REMARKS

Remarks to the Drawings

APPLICANT(S): EDLIS, Ofir et al. 09/780,470

ANNOTATED SHEET SHOWING CHANGES

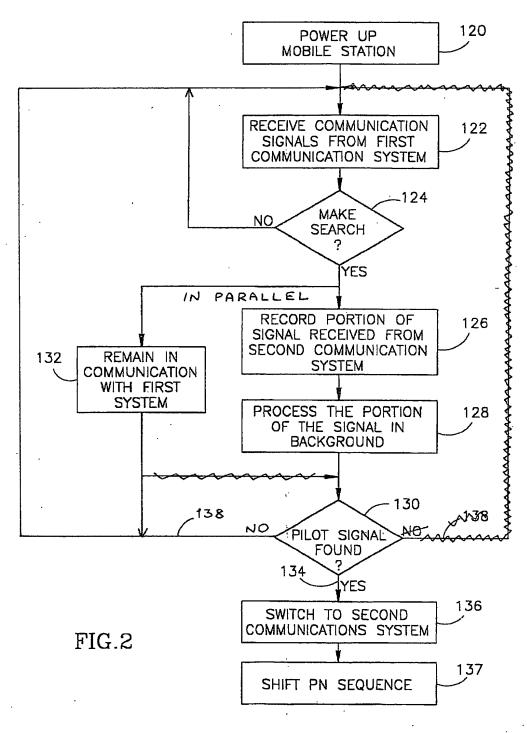
Fig. 2 has been amended to reflect the text on page 5, lines 19 to 21, by adding the words "IN PARALLEL" at the start of the diverging paths that follow step 124, and continuing step 132 in parallel with steps 126, 128 and 130 until an affirmative answer is reached to "PILOT SIGNAL FOUND" in step 130. No new matter has been added.

ANNOTATED SHEET SHOWING CHANGES

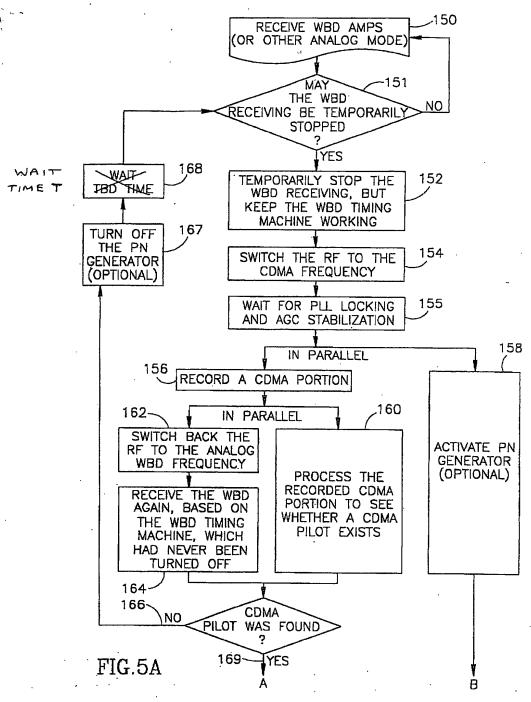
Fig. 5A has been amended in the interests of clarity, by altering step 168 to read "WAIT TIME T". No new matter has been added.

FIG.8

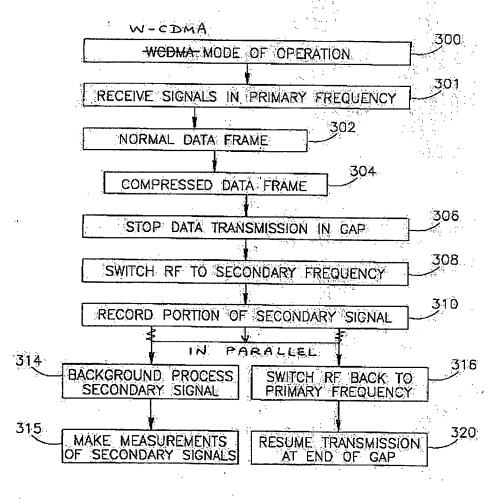
Fig. 8 has been amended to reflect the text on page 9, lines 1 to 6. In Fig. 8, the divergent paths following step 310 have been redrawn, and the words "IN PARALLEL" have been added. No new matter has been added.
